1. Type of Well	8. Well Name and No. SKELLY UNIT 961							
Oil Well Gas Well Ot     Ot	9. API Well No.							
CHEVRON USA INCORPOR		30-015-34324-00-S1						
3a. Address 6301 DEAUVILLE BLVD MIDLAND, TX 79706	o. (include area code) 38-4044		10. Field and Pool or Exploratory Area FREN

#### Current WBD - Skelly Unit #961

## Permanent Abandonment of Federal Wells Conditions of Approval (LPC Habitat)

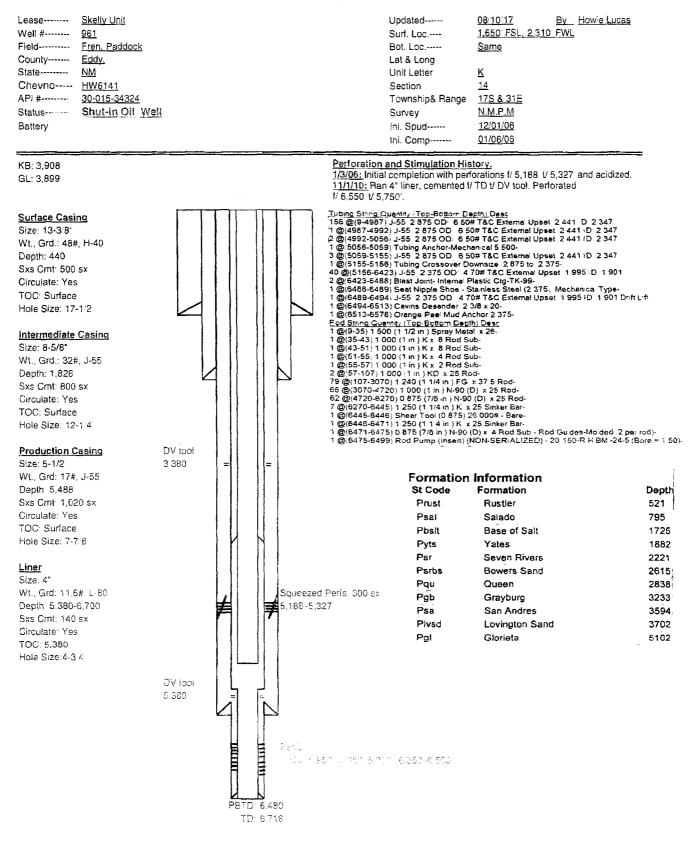
OCT 2 4 2017							
		LAMATION I ATTACH	PROCEDURE IED					
						OFMENOVAL		
below grow	nd level a	lay h	sle ma	ecter	require			
14. I hereby certify that the foregoing i	#Electronic Submission For CHEVRON	7 384655 verifie JSA INCORPO	d by the BLM We RATED, sent to t	the Carlsbad	n System			
Name(Printed/Typed) HOWIE L	AMES AMOS on C Title ENGINE	•	/JA01595E)					
				······				
Signature (Electronic	Date 08/14/2							
	THIS SPACE FO	DR FEDER/	AL OR STATE		SE			
Approved By hames a. Currens			Title 51	1ET		10-13-17 Date		
Conditione of approval, if any, are attached certify that the applicant holds legal or eq which would enable the applicant to condu-	Office C	50						
title 18 U.S.C. Section 1001 and Title 43 States my false, fictitious or fraudulent	U.S.C. Section 1212, make it a statements or representations as	crime for any p to any matter w	erson knowingly and ithin its jurisdiction.	willfully to ma	ke to any department or	agency of the United

(Instructions on page 2) ** BLM REV	ISED ** BLM REVISE	) ** BLM R	EVISED ** BLN		** BLM REVISE	D **
